Beaver Valley Power Station - Units 1 & 2

Radioactive Effluent Release Report

Unit 1 and 2 Offsite Dose Calculation Manual Changes

Change (24) of the ODCM (Effective: June, 2007)

FIGURE 1.4-3
BV-1 AND 2 LIQUID EFFLUENT RELEASE POINTS

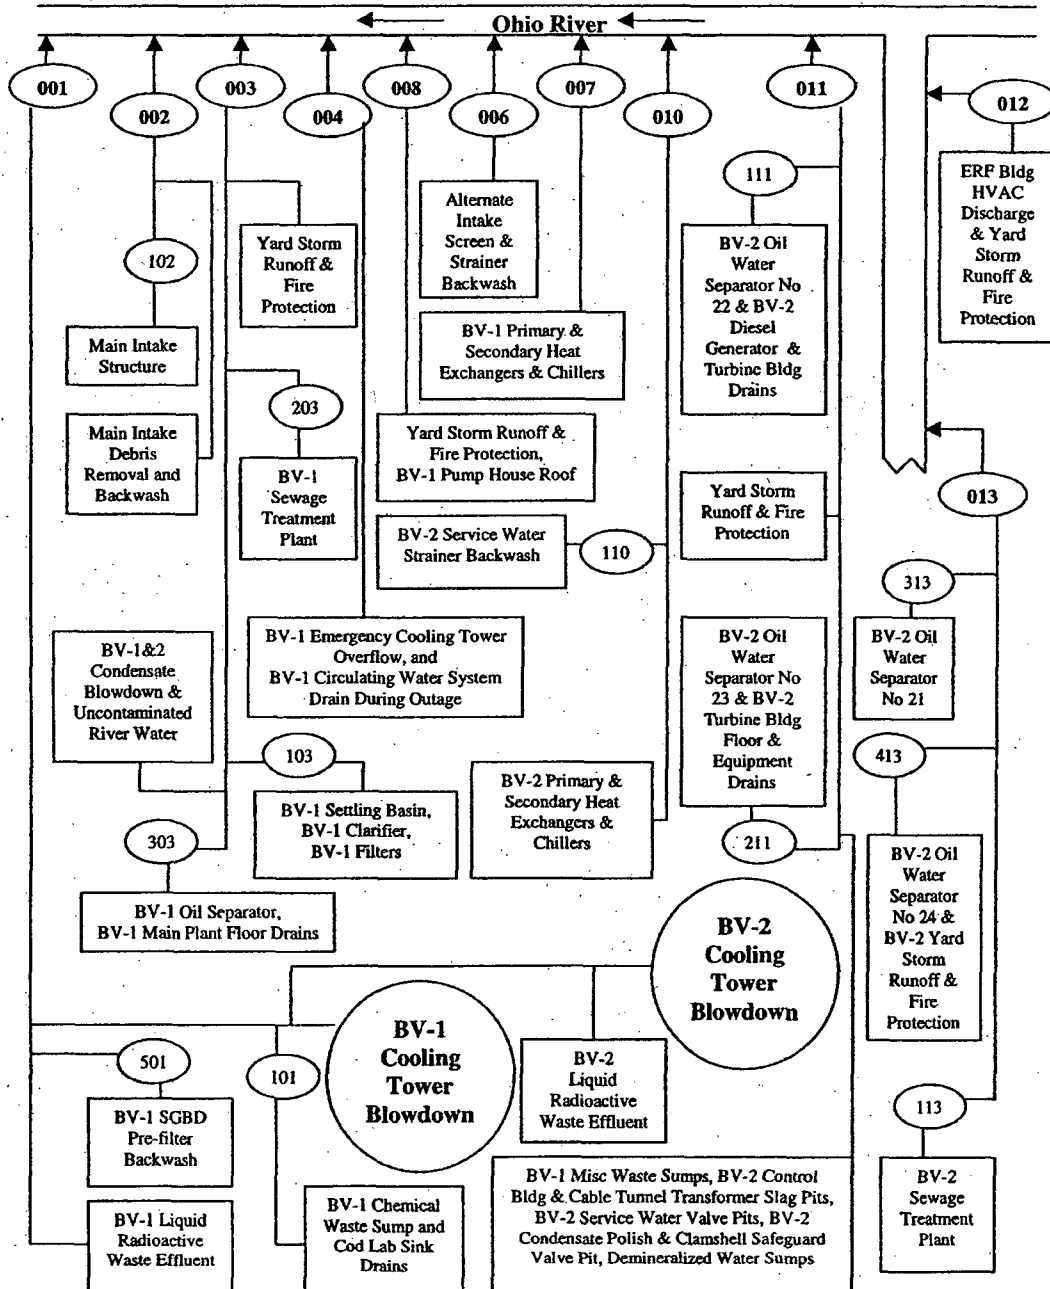
3.2.2.30	CR05-03854, ODCM Figure for Liquid Effluent Release Points Needs Updated. CA-01, revise ODCM procedure 1/2-ODC-2.01 (ODCM: Liquid Effluents) Attachment D, Figure 1.4-3 to incorporate a modified version of Plant Drawing No. 8700-RM-27F.

FIGURE 2.4-2

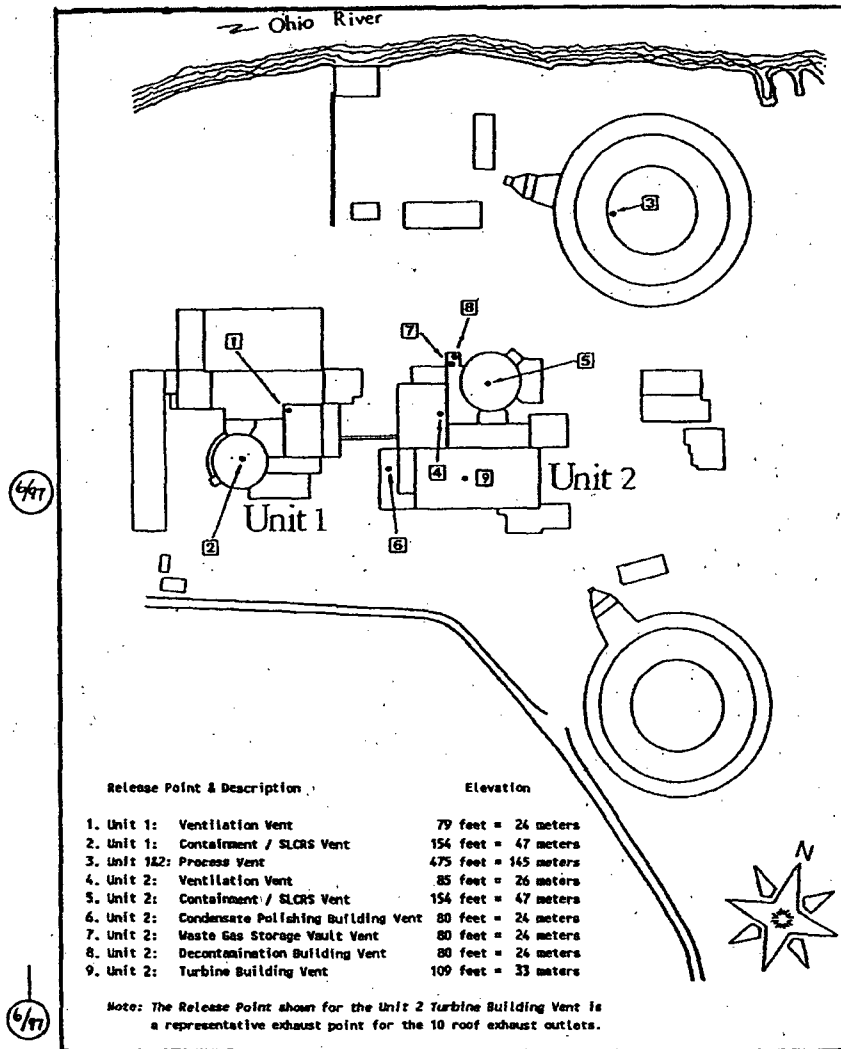
8.2.10.1.1	<u>Section 2.0</u> : A release point for the BV-2 Turbine Building Vent was added (for editorial purposes) to Figure 2.4-2.		
8.2.10.2	The justification used for Change (10) to the ODCM is as follows:
